Form 3160-5
(June 2019)UNITED STATES
DEPARTMENT OF THE INTERIOR
BUREAU OF LAND MANAGEMENTFORM APPROVED
OMB No. 1004-0137
Expires: October 31, 2021**SUNDRY NOTICES AND REPORTS ON WELLS**
Do not use this form for proposals to drill or to re-enter an abandoned well. Use Form 3160-3 (APD) for such proposals.5. Lease Serial No.
NMSF078773
6. If Indian, Allottee or Tribe Name**SUBMIT IN TRIPLICATE - Other instructions on page 2**

ROSA UNIT 742H

LOGOS Operating request a change in plans for the following:

Attached: New C102, Operations plan (based on KB) and Directional Drill plan (based on GL).

Plan: Plan #5 (Rosa Unit #742H/OH)

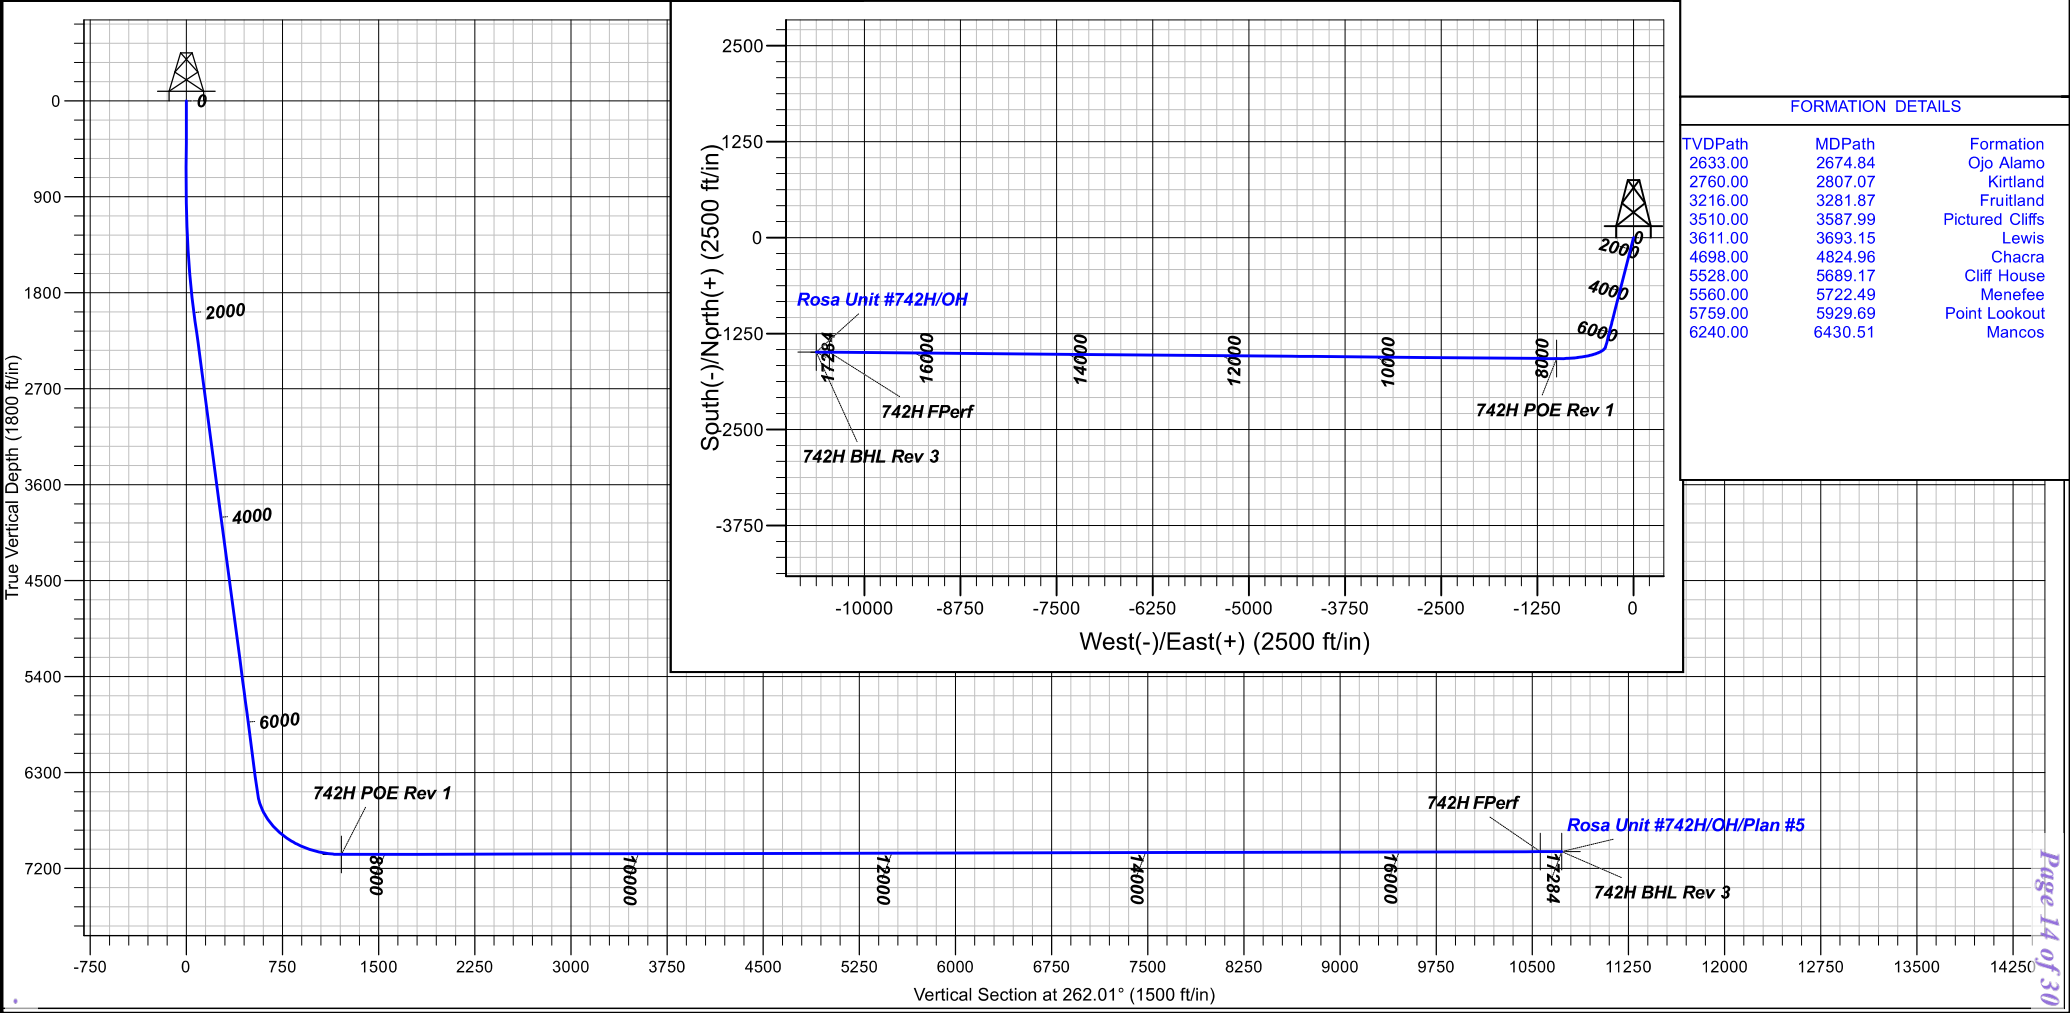
Original surface-hole location from 378' FNL & 1695' FWL to new **surface-hole location 334' FNL & 1682' FWL**Original TD @ 17,443' MD 7,042' TVD to new **TD @ 17,309' MD 7,067' TVD.**

Original KOP @ 6,323' MD 6,156' TVD to new **KOP @ 6,723' MD 6,522' TVD**Original Landing point @ 7,817 MD 7,069' TVD to new **Landing point @ 7,683' MD 7,094' TVD**Original 9.625" casing Intermediate @ 6,485' MD to new **Intermediate @ 6,531' MD 6,361' TVD****Additional 13.375" casing Intermediate @ 3,663' MD 3,607' TVD**Original 5.5" casing Production @ 17,443' MD to new Production @ **17,309' MD 7,067' TVD**
